From: edover@lowerchurchillproject.ca
Sent: Thursday, July 23, 2015 4:01 PM
To: ken.mcclintock@lowerchurchillproject.ca; John Mulcahy
Subject: Fw: CH0009 Site Interface Issues
Attachments: HJOC-Dragados Clarification Response July 23 2015.pdf

RE: CH0009 Site Interface Issues

CH0009 – CONSTRUCTION OF NORTH AND SOUTH DAMS
Request for Proposal

C:\Users\lavelin\OneDrive\Desktop\2014\1447_LCP_040009\Draws for Brad\July 22\ Bridge Realignment Option 1.dwg

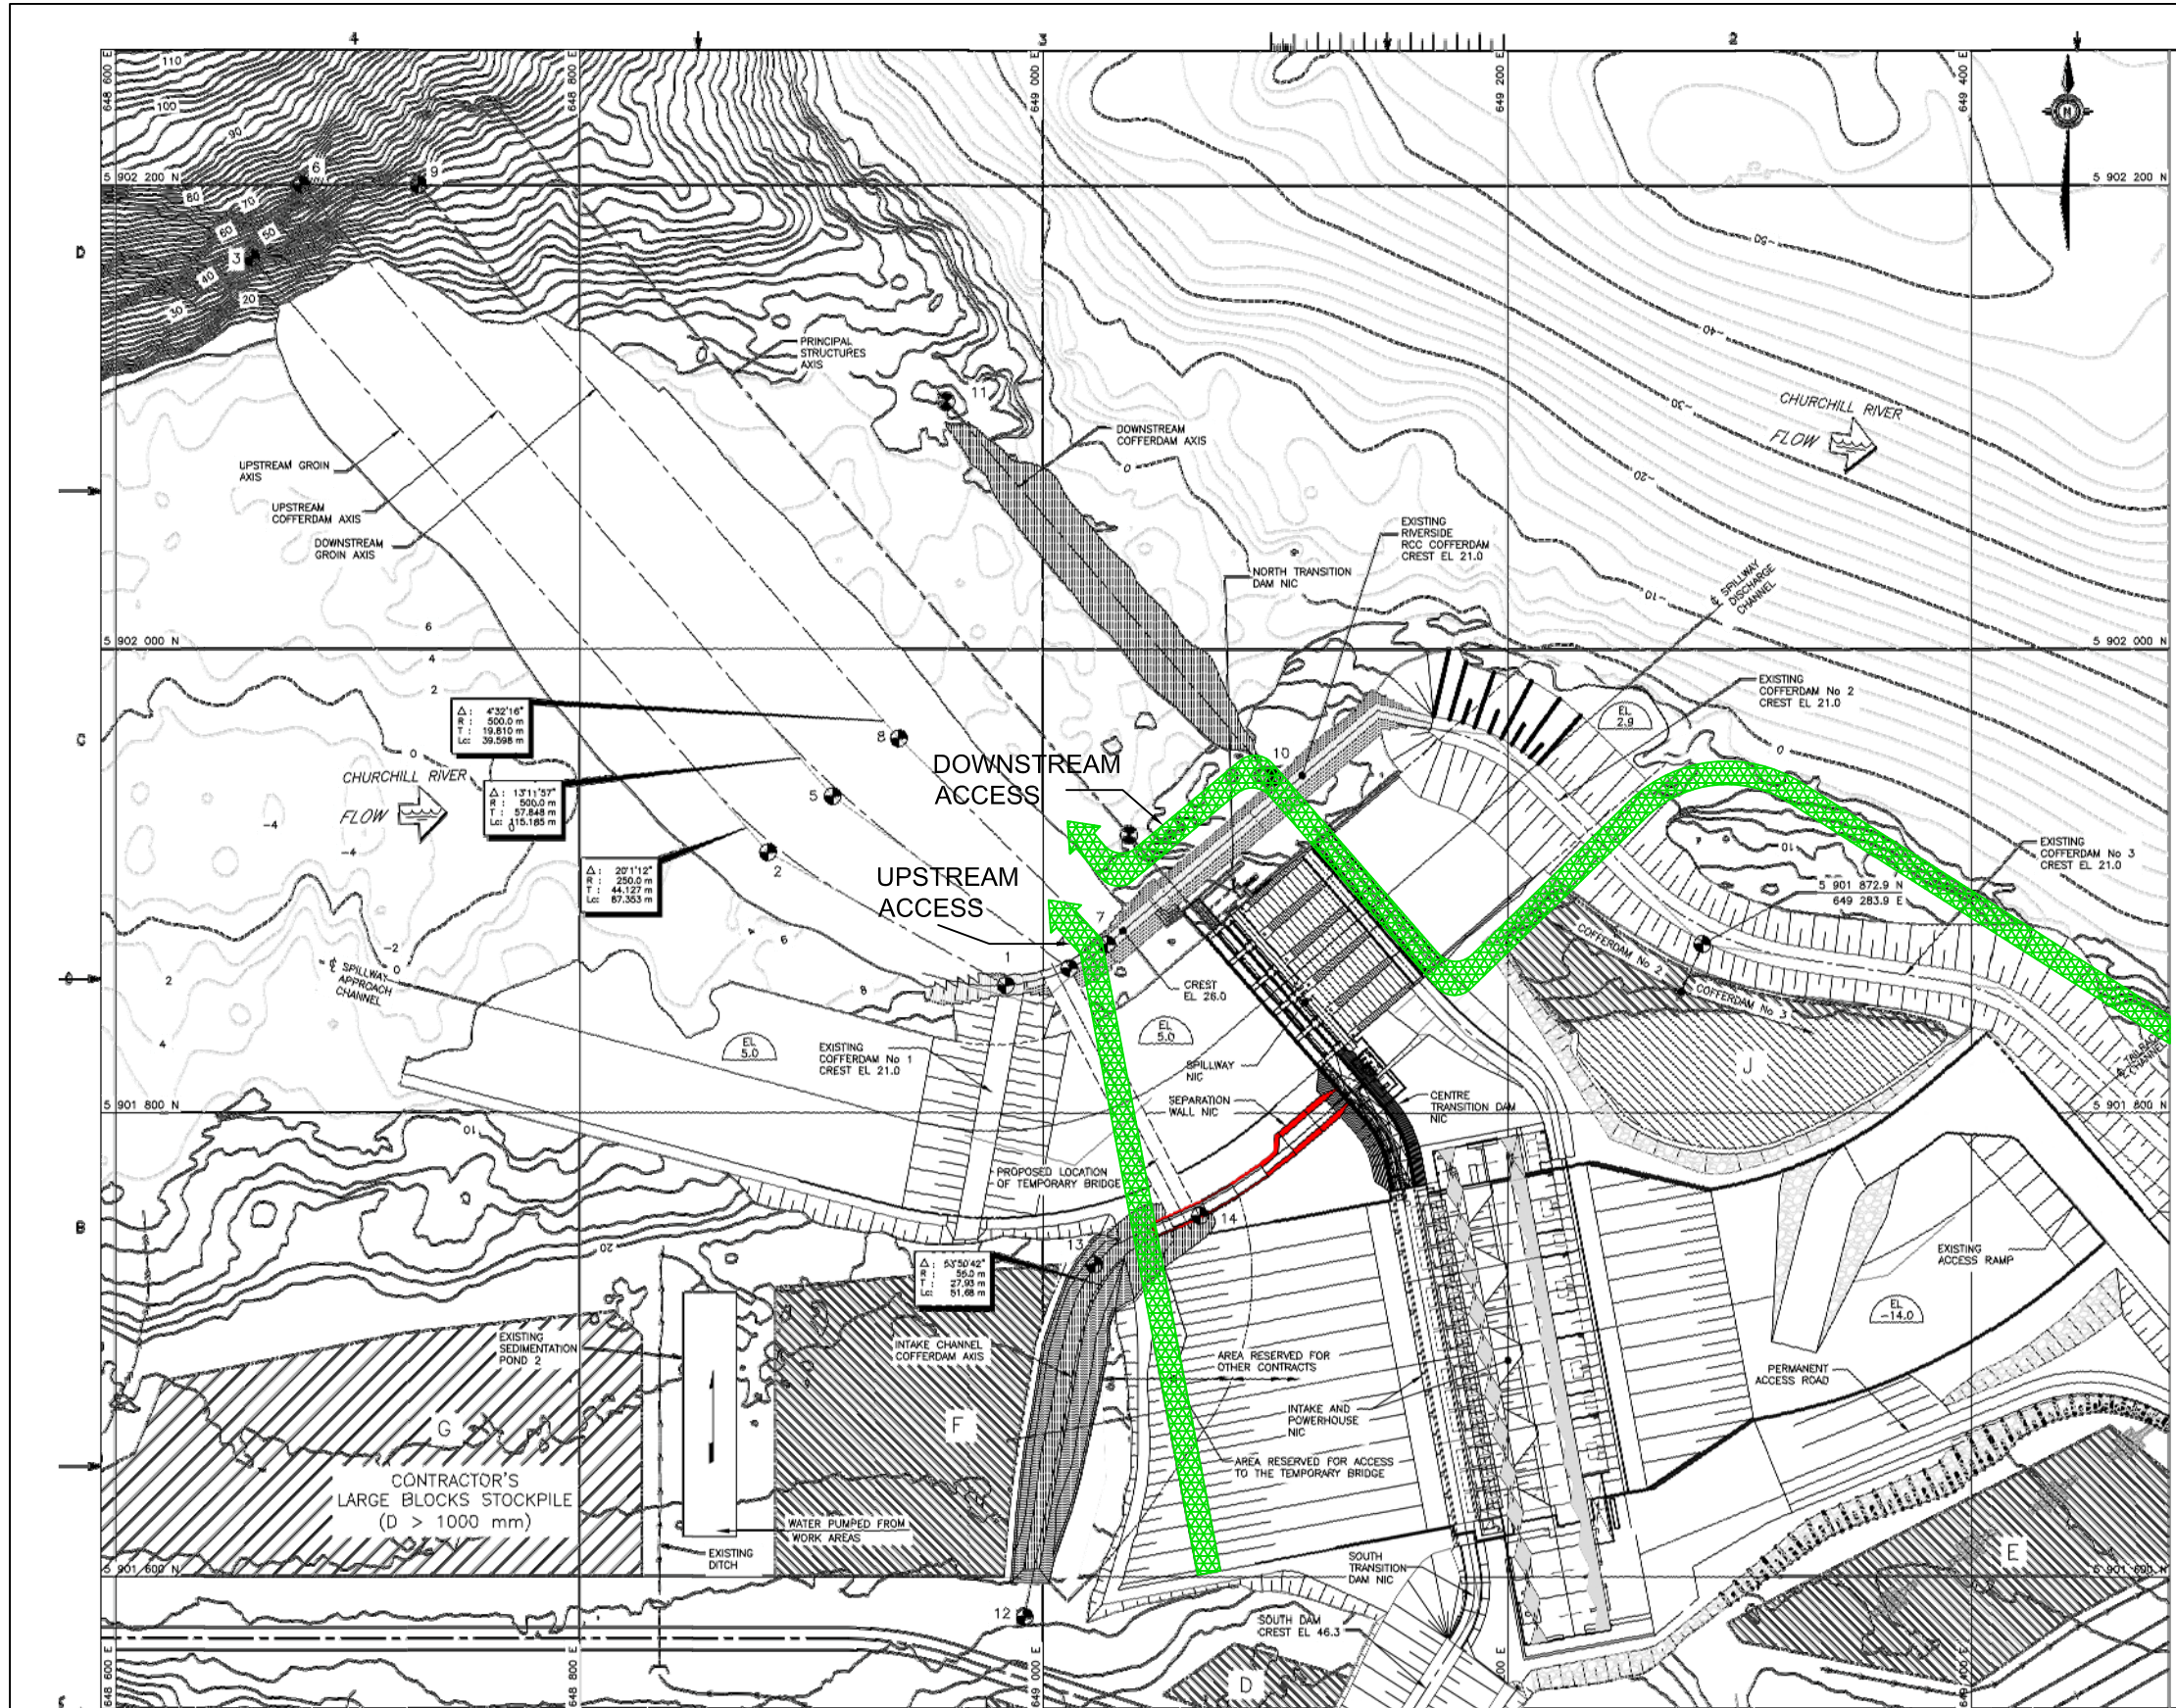
The need to give up access to the area immediately East of the Intake Cofferdam. Minor adjustments to the cofferdam layout may be possible to facilitate access to the upstream temporary bridge.

We have reviewed this requirement and we can minimize our impact to this area by realigning the upstream bridge. We will now utilize the intake cofferdam as the launching pad. However we will require some fill on the east side of the cofferdam in order to allow a straight launch. The construction of the Intake cofferdam will have to be completed in the fall of 2015 in order to accommodate a bridge installation in the spring of 2016. This will cause some access interference to the intake area of the powerhouse however we will do our best to minimize this disruption.

The additional cost for this adjustment at the bridge abutments and launching area is \$300,000.00. This cost is based on the realignment we have chosen. If a different alignment is required that lengthens the span then there would be additional costs for the extra length of bridge and potential extra pier installation and removal. This cost could be substantial.

The temporary bridge across the spillway approach channel will consist of one 80m span and one 20m (+/-) span as illustrated on the attached drawing. We will realign the bridge to match up closer to the intake cofferdam. This will minimize any encroachment into the intake area as requested in your email to Mr. Leonard Knox dated July 21, 2015. We may require some fill on the inside of the cofferdam in order to create a straight launching area. This can be removed after the bridge is installed.

Annex A13-11

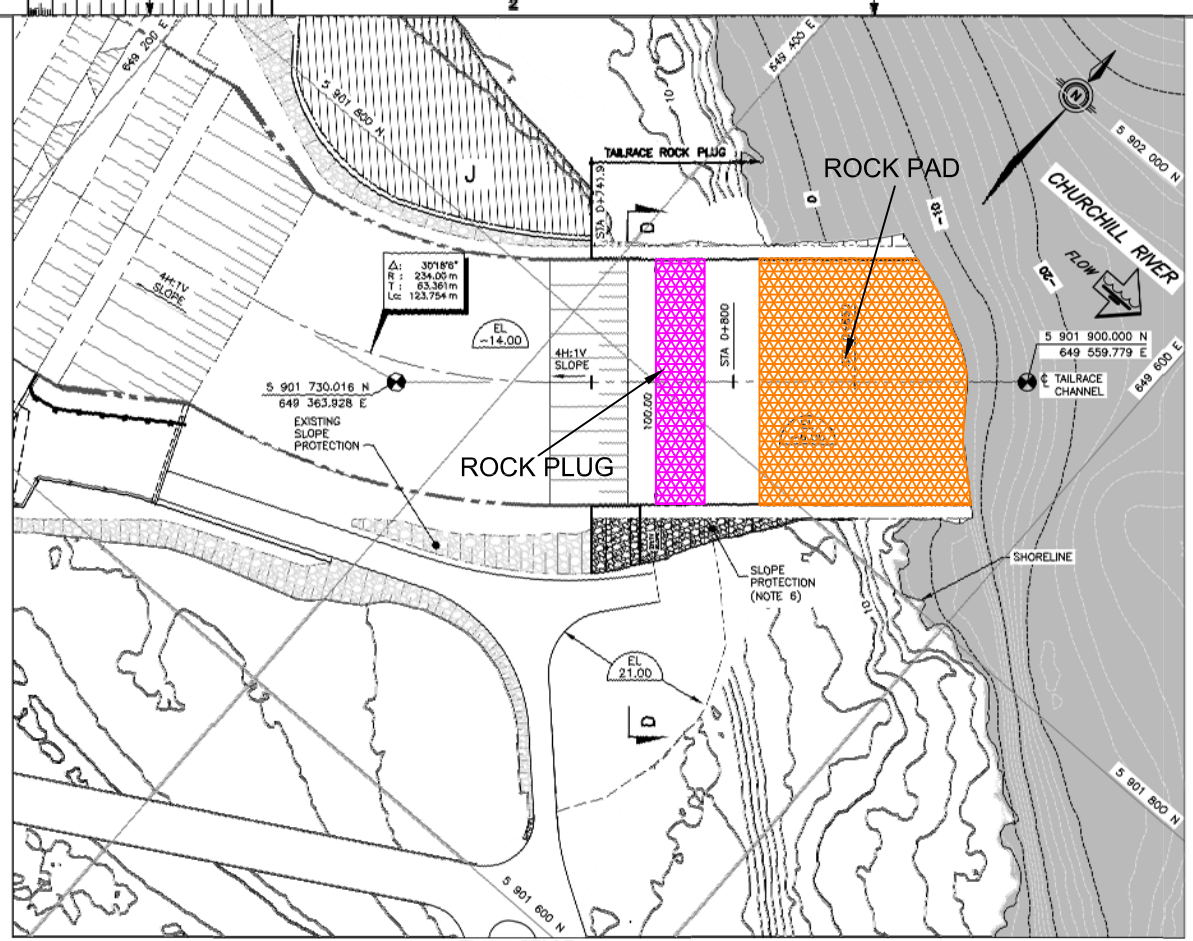
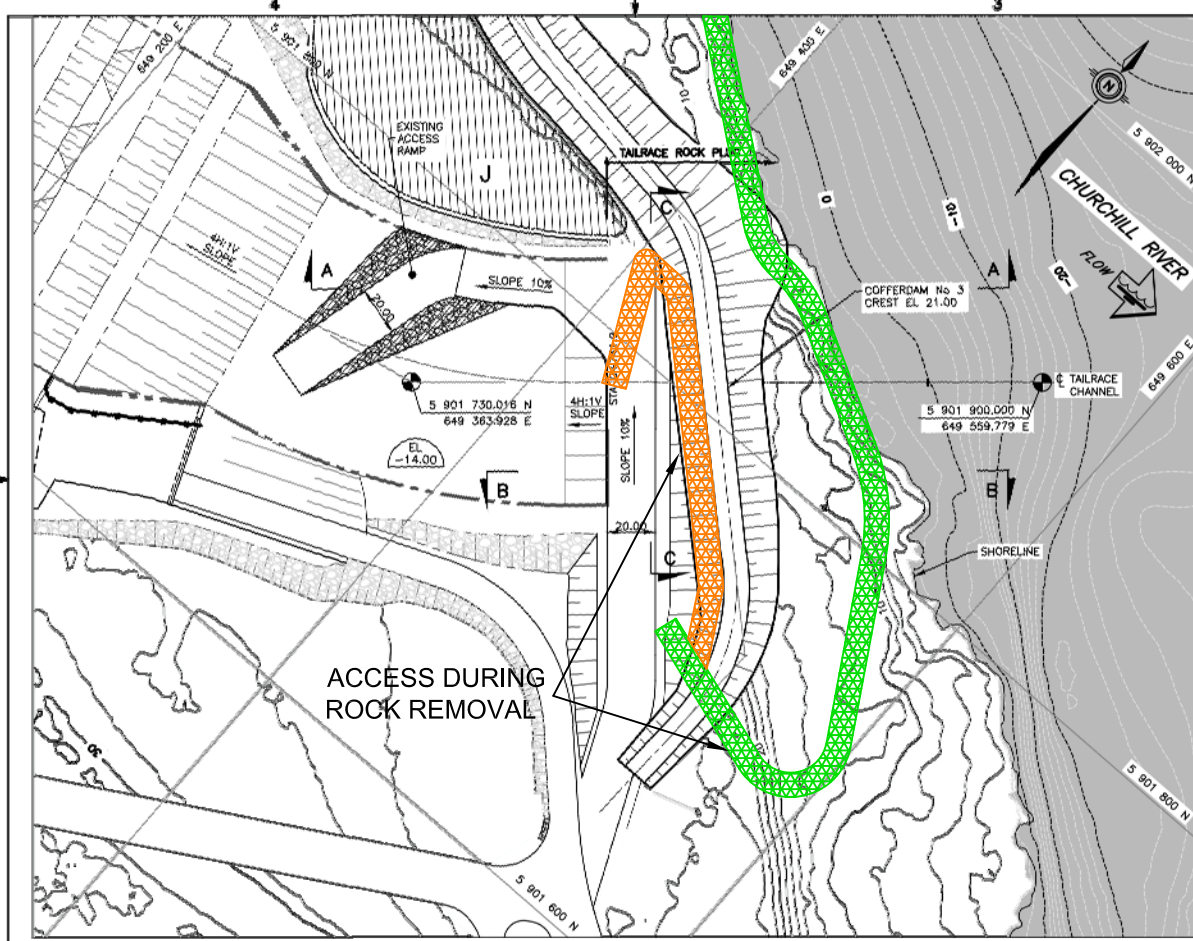
The access to Area J will change once the existing cofferdams and rock section is removed. Please refer to Annex 13-4 and 13-11 drawings. A copy of each has been attached.
